PROJECT: NHPP-0002-06(022)/107209301 - Lee

SECTION 904 - NOTICE TO BIDDERS NO. 6694

SUBJECT: Additional Detail Sheets

PROJECT: NHPP-0002-06(022) / 107209301 – Lee County

Notice To Readers No. 624 ENGLISH	Working Number SSD-4C Cont'd.
REVISION	SHEET NUMBER

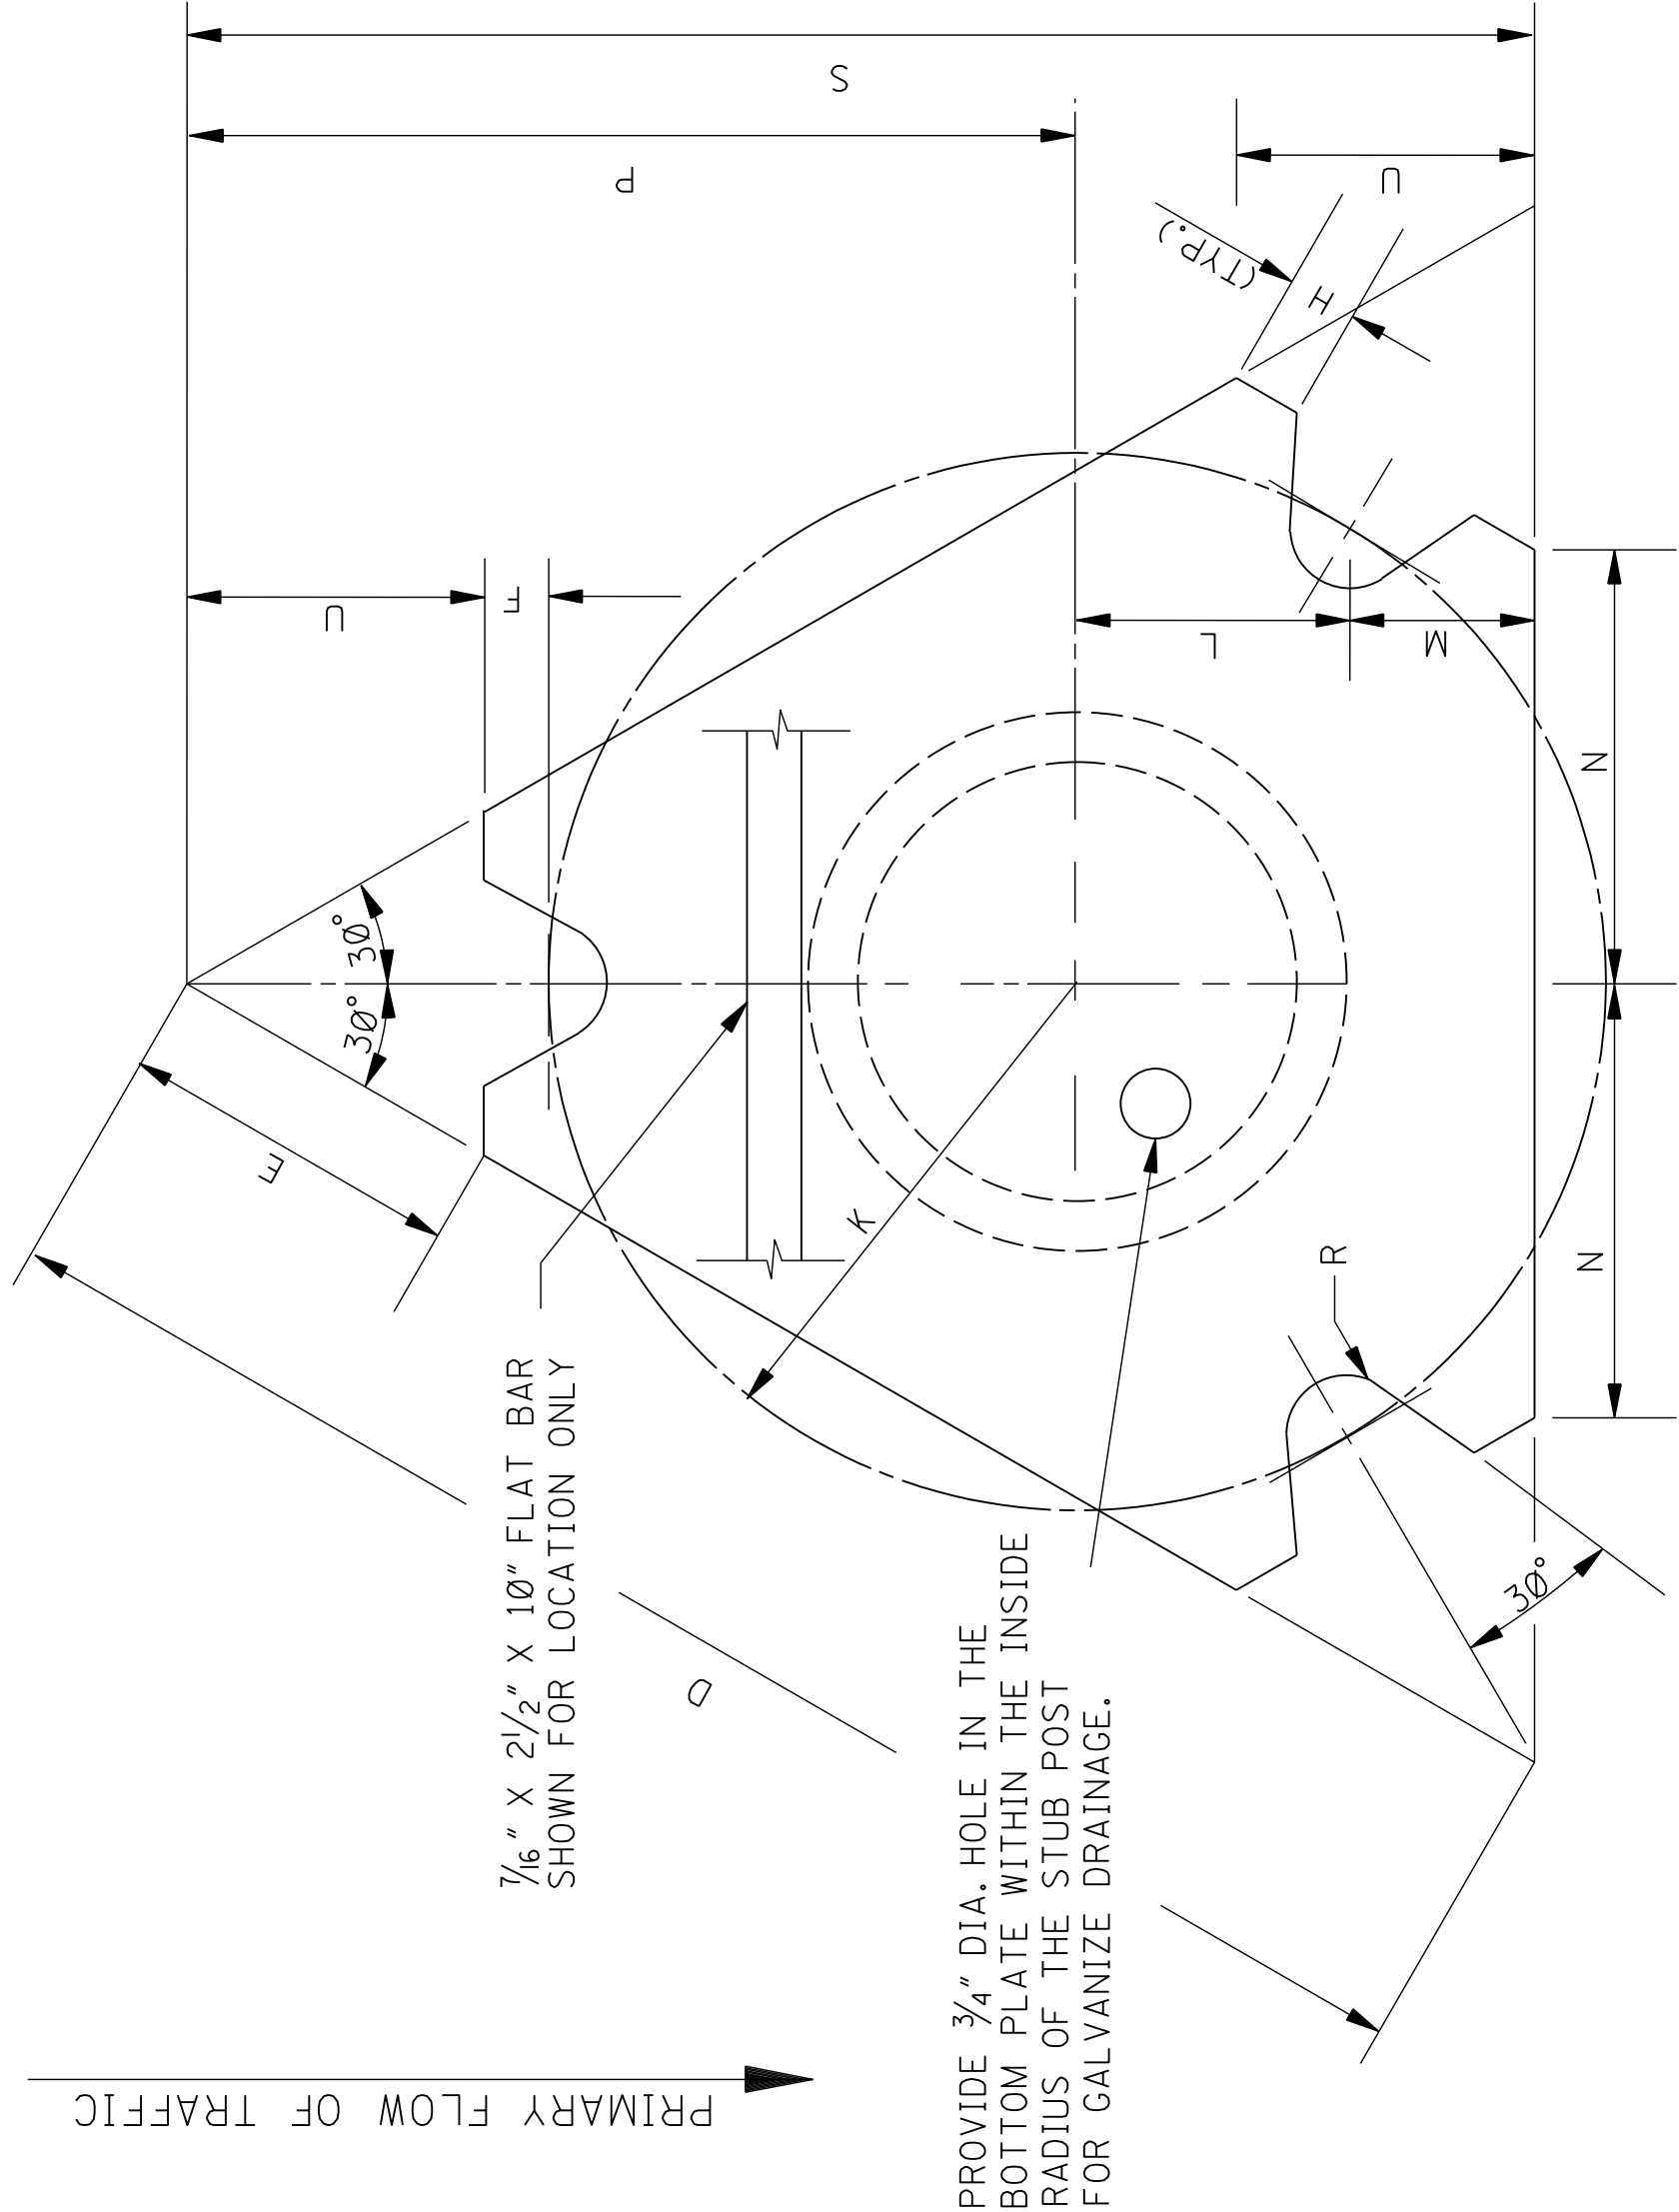
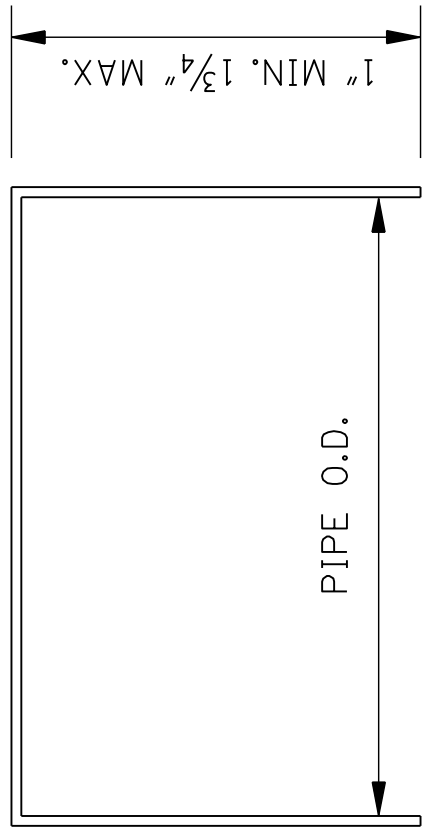
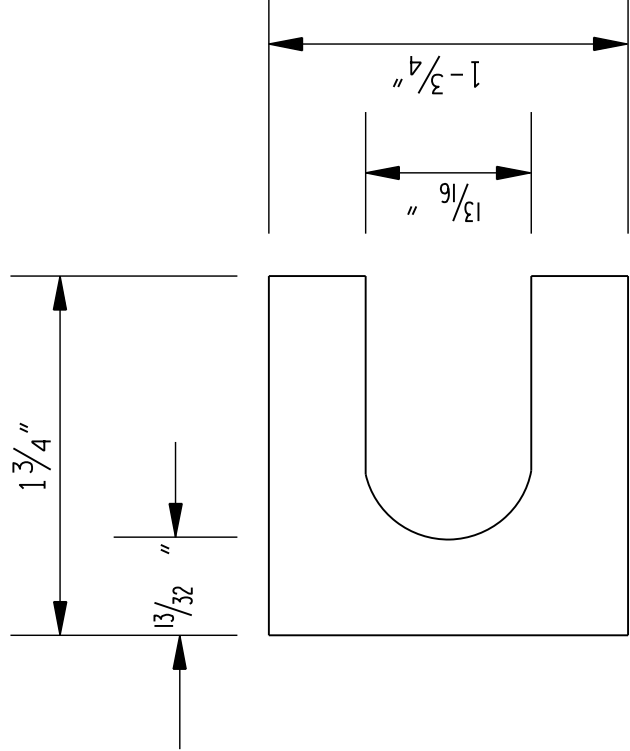
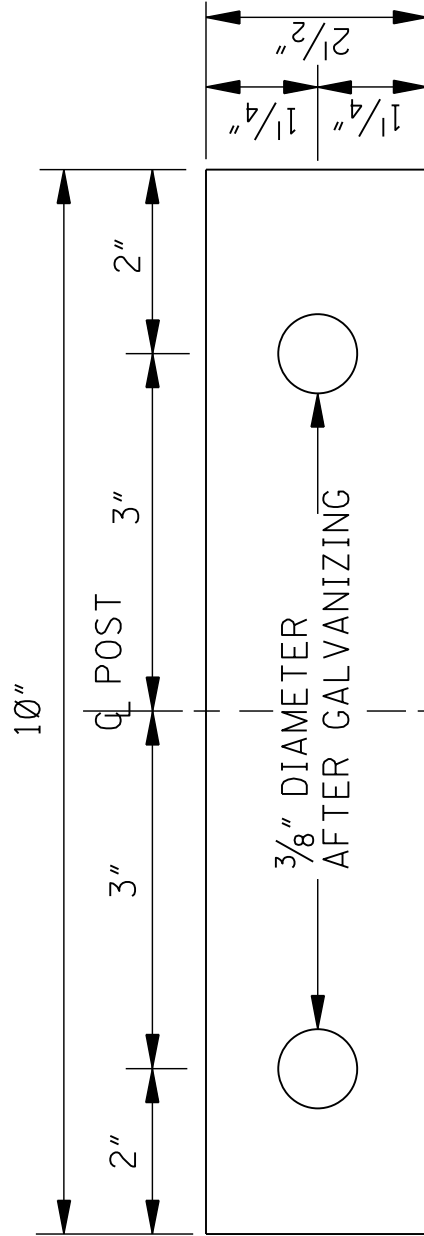
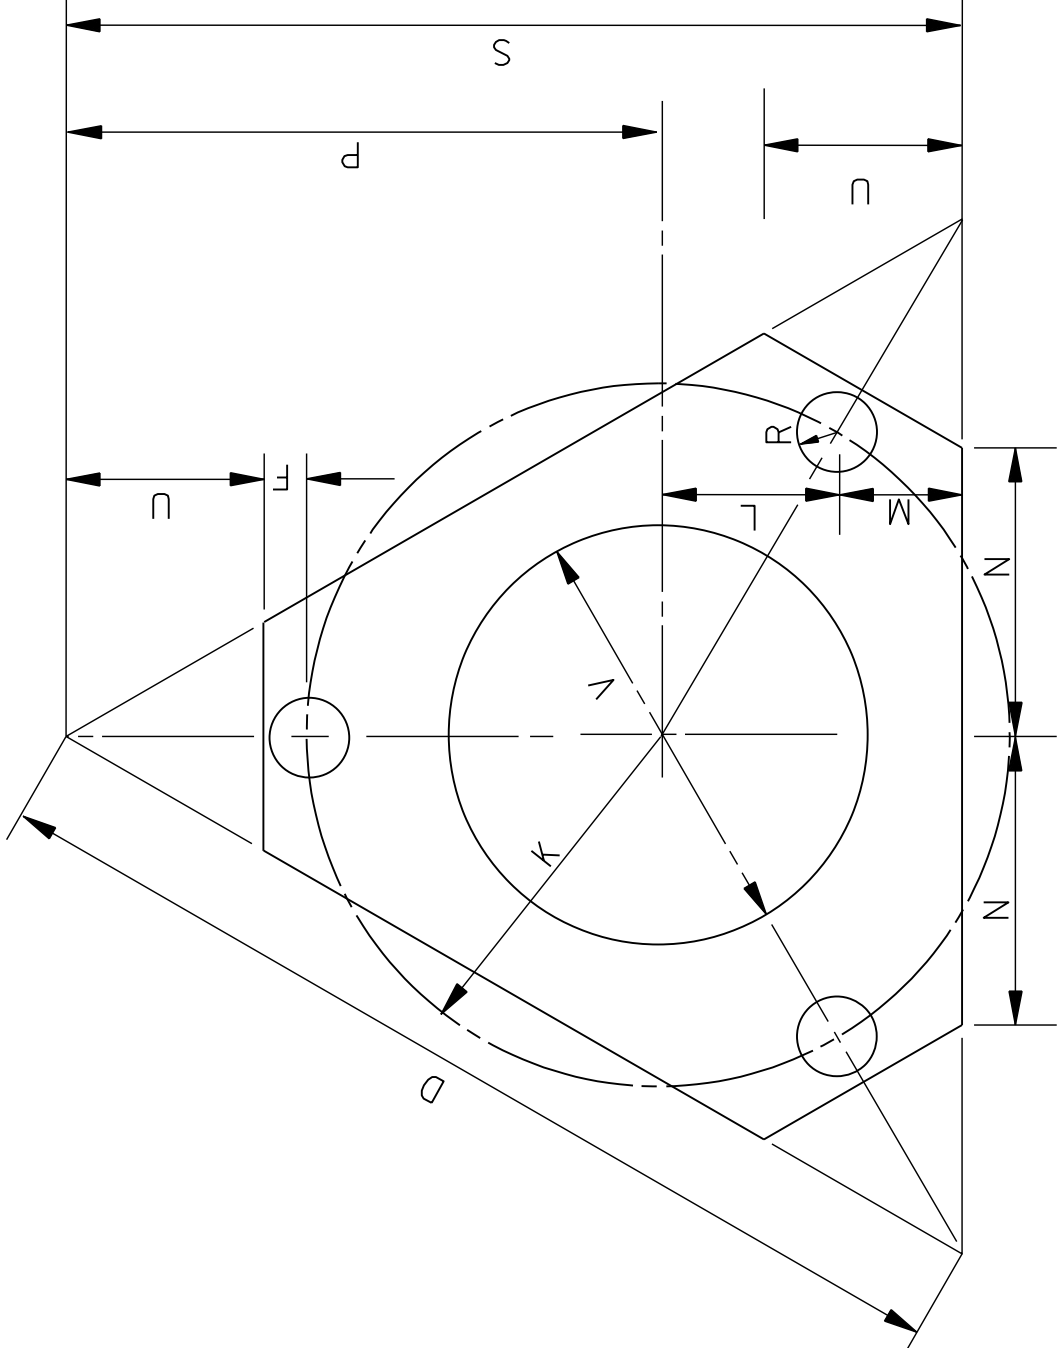
The Bidder is advised that Working Sheets SSD-1 and SSD-4C were inadvertently left out of the Contract Plans. The following drawings attached hereto shall govern appropriate items of required work.
